CITY PLANNING COMMISSION

APPLICATION: A. Negative Declaration

B. Plan Review for a 192 unit apartment complex

WATERFORD COVE APARTMENTS

SITE PLAN

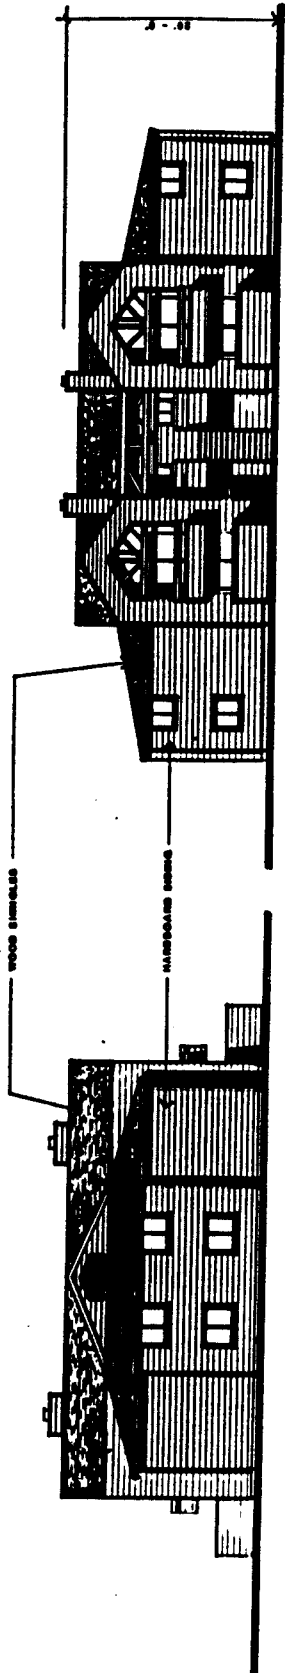
The site plan has some minor deficiencies which must be modified and submitted for staff review and approval prior to issuance of building permits which include:

1. No trash enclosures are indicated (size, location, number). All enclosures must be constructed to City standards.
2. A complete landscape/irrigation plan was not submitted. Staff recommends that all street frontage be landscaped with a four foot high berm and, in addition, that the area along the west property line be heavily landscaped with trees and shrubs in order to buffer the proposed use from the adjacent lower density use.

3. In order to reduce the impact of two-story units along Windbridge Drive, staff recommends that both one and two-story units be constructed along this frontage. Since the property to the east is zoned R-2B-R and will, in all likelihood, be developed with apartments or condominiums, staff does not wish to create a tunnel effect with two-story located along the entire length of the street on both sides. The building height variation will help reduce this problem. A revised elevation and site plan must be submitted for staff review and approval prior to issuance of building permits.

4. Since no commonstorage area has been provided on-site, staff recommends that the applicant prohibit the storage or parking of RV's, trailers, boats, etc. in the parking lot.

TYPICAL FRONT ELEVATION

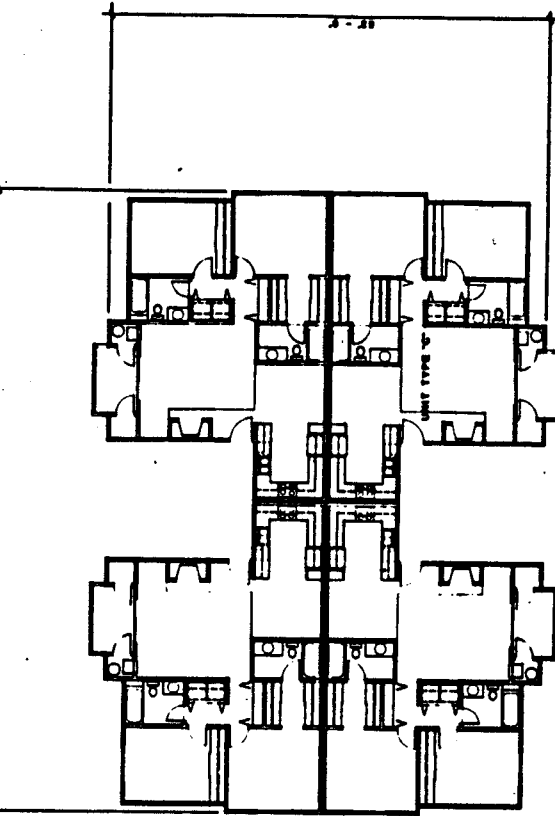
- C. Staff has reviewed the proposed site plan and building elevations. The buildings would be similar to the existing dwellings immediately north of the site and compatible with other developments in the area. The only deficiency is that carport elevations and building material descriptions were not included and must therefore be submitted for staff review and approval prior to the issuance of building permits.
